Green Hill Solar Farm

EN010170

Applicant's Response to Stop Green Hill Solar

Document Reference: EX4/GH8.1.29

Insert 1: Extract from the Provisional ALC

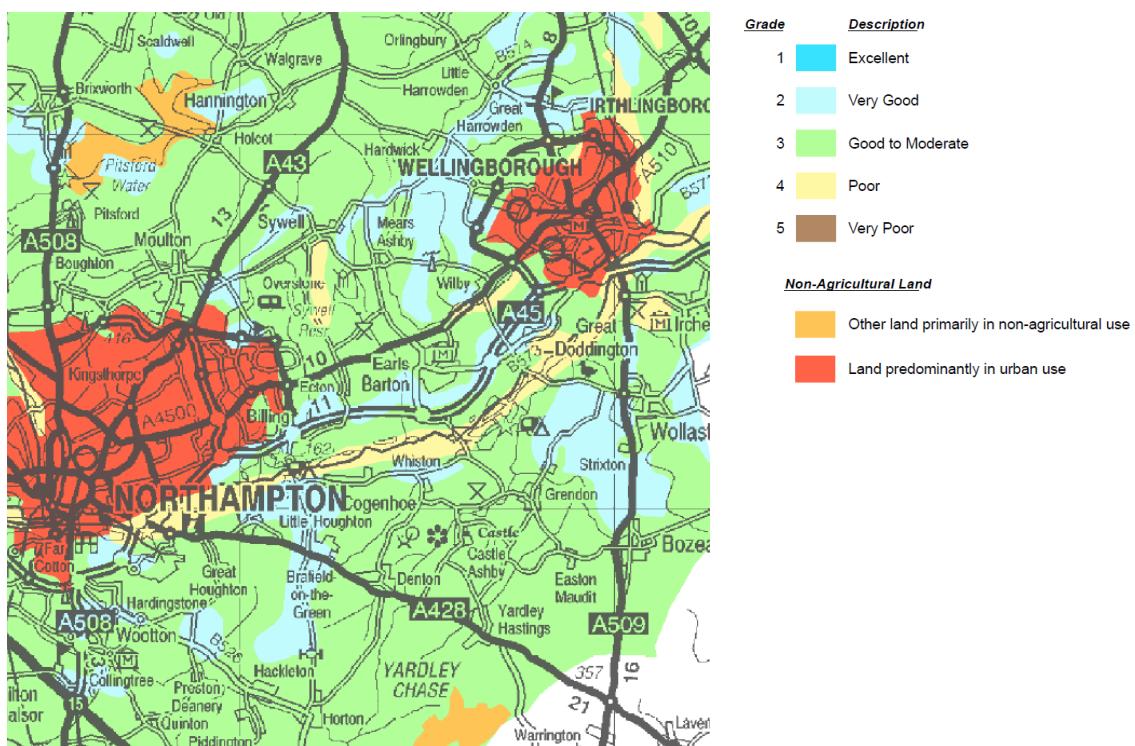
2.2 Site Selection. The site selection process was described in the ES Chapters 5: Alternatives and Design Evolution [APP-042] and 20: Agricultural Circumstances [APP-057] and further land quality data was provided in the Farming Report [APP-571]. Inserts 1 and 2 from the Farming Report show the provisional ALC mapping, and the Likelihood of Best and Most Versatile (BMV) mapping, which identified mostly a 20-60% or >60% likelihood of BMV land locally.

2.3 The mapping did not, therefore, provide evidence of areas where the proportion of land required for the Scheme of BMV quality was likely to be low (i.e. it was mostly moderate or high likelihood). Smaller areas of low likelihood are generally likely to be affected by floodwater as they clearly follow main water courses.
